MIL-PRF-19500/337G
AMENDMENT 2
25 July 2000
SUPERSEDING
AMENDMENT 1
8 November 1999

PERFORMANCE SPECIFICATION SHEET

SEMICONDUCTOR DEVICE, DIODE, SILICON, SWITCHING
TYPES 1N4153, 1N4153-1, 1N4153UR-1, AND 1N4534
JAN, JANTX, JANTXV, AND JANS

FIGURE 3. Mounting arrangement. "

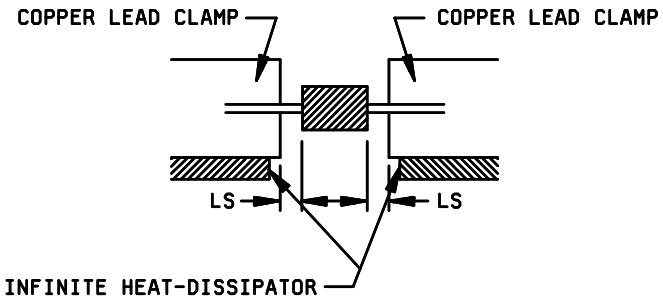
* Add the following new paragraph:

" 4.5.3 Thermal resistance. Thermal resistance measurement shall be performed in accordance with MIL-STD-750, method 3101 or 4081. Forced moving air or draft shall not be permitted across the devices during test. The maximum limit for $R_{\theta JL}$ under these test condition shall be $R_{\theta JL(max)}$ = 250°C/W and $R_{\theta JEC(max)}$ = 100°C/W. The following conditions shall apply:

I_H = 75 mA to 300 mA.

t_H = 25 seconds minimum.

I_M = 1 mA to 10 mA.

t_{MD} = 100 µs maximum.

LS = Lead spacing = 9.53 mm (.375 inch) as defined on figure 3.
